2017-022 \_\_\_\_\_ BWR Vessel & Internals Project (BWRVIP)

Subject: Project No. 704 – BWRVIP Response to RAIs on BWRVIP-41, Rev. 4 to NRC

**BWRVIP Responses to NRC Requests for Additional Information on  
BWRVIP-41, Revision 4: Jet Pump Inspection and Flaw Evaluation  
Guidelines**

**Figure 4A: Plan View of Typical BWR Reactor**  
 (excerpted from BWRVIP-281NP, Figure 3-2)

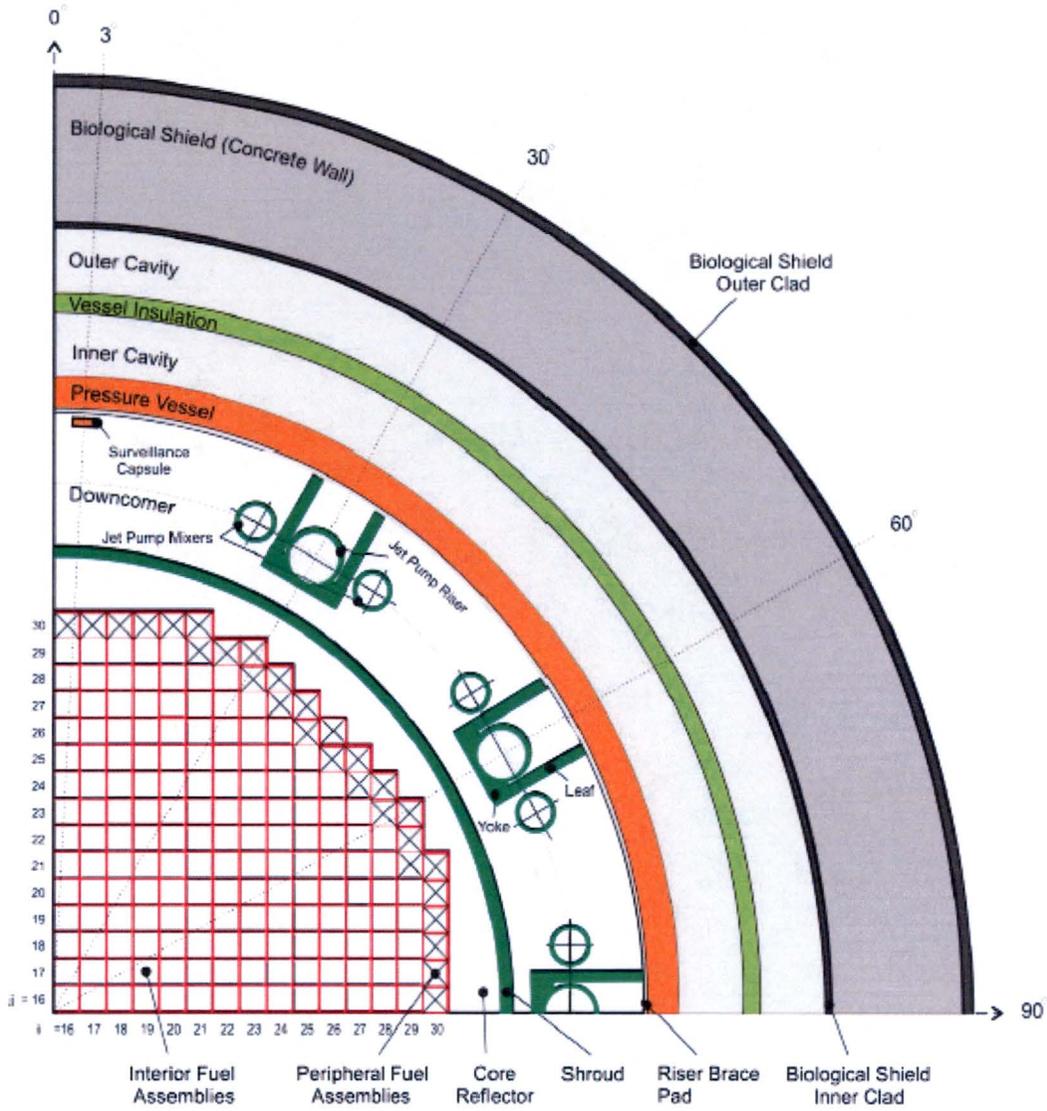
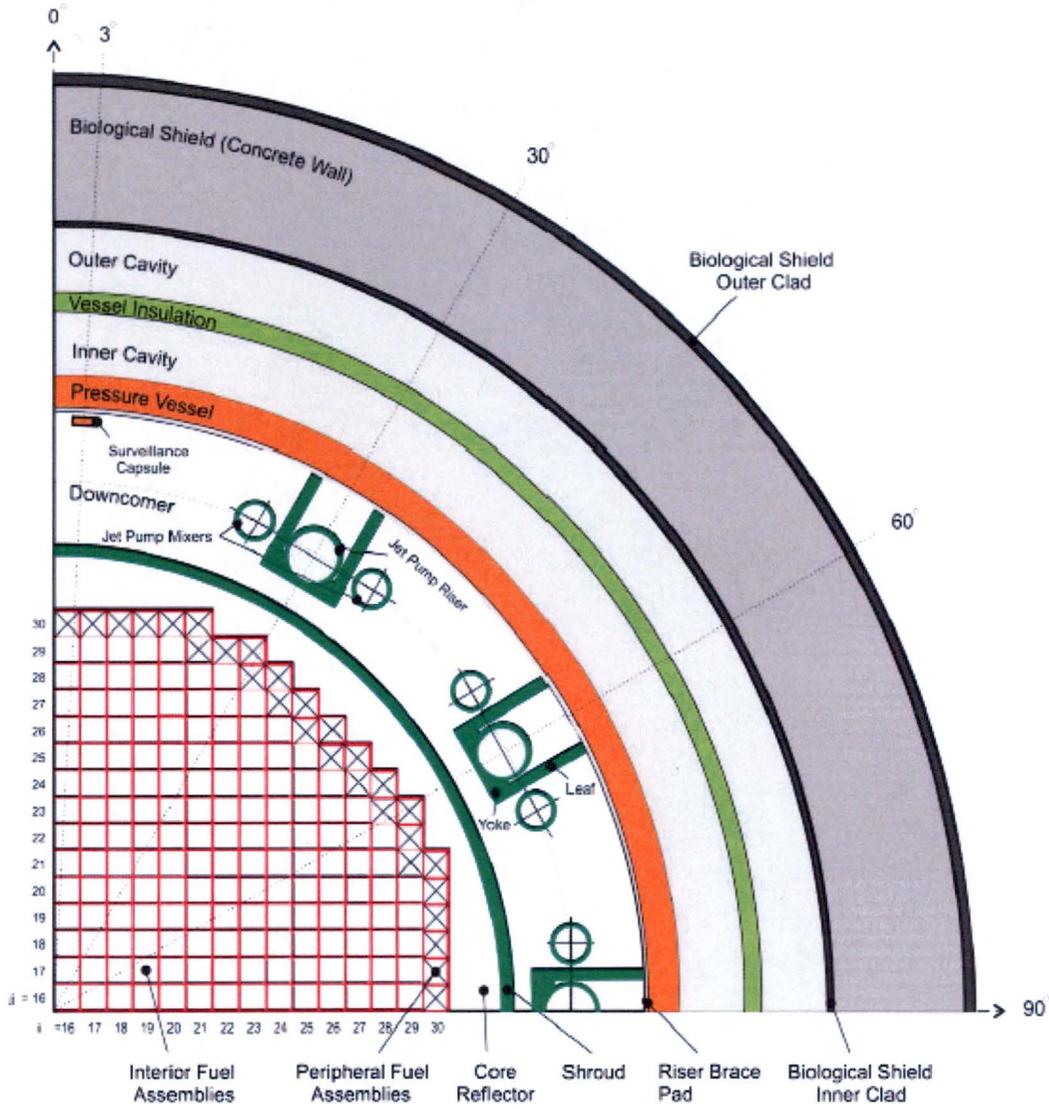
Background: The staff notes that MRP-175, Figure B-2, shows that failures in BWRs related to irradiation-assisted stress corrosion cracking (IASCC) start to occur when the fluence reaches about  $5 \times 10^{20}$  n/cm<sup>2</sup>. The staff notes that some jet pump components in a foreign BWR have been exposed to fluence above  $5 \times 10^{20}$  n/cm<sup>2</sup> [Ref. 4].

Request: The staff asks the BWRVIP to include a discussion of IASCC and how the neutron exposure of the jet pump assembly in the US domestic BWR fleet varies with location within the vessel and over the expected 60 year service life.

As anticipated, differences in plant design were found to result in significant variations in jet pump EOL fluence. Design factors affecting EOL fluence estimates include, but are not limited to, reactor size, number of fuel bundles / fuel arrangement, power uprate status, and the size of the annulus region. Further, within a single plant, some jet pumps are subject to higher fluence than others as a result of azimuthal location. Since the fuel bundles are rectangular, the distance from the edge of the core to the jet pump varies somewhat, resulting in different EOL fluence estimates. Figure 4A provides a plan view

of the reactor core, core shroud, and jet pumps that illustrates this geometry. The fluence values presented below are based on the highest fluence jet pump in each unit evaluated.
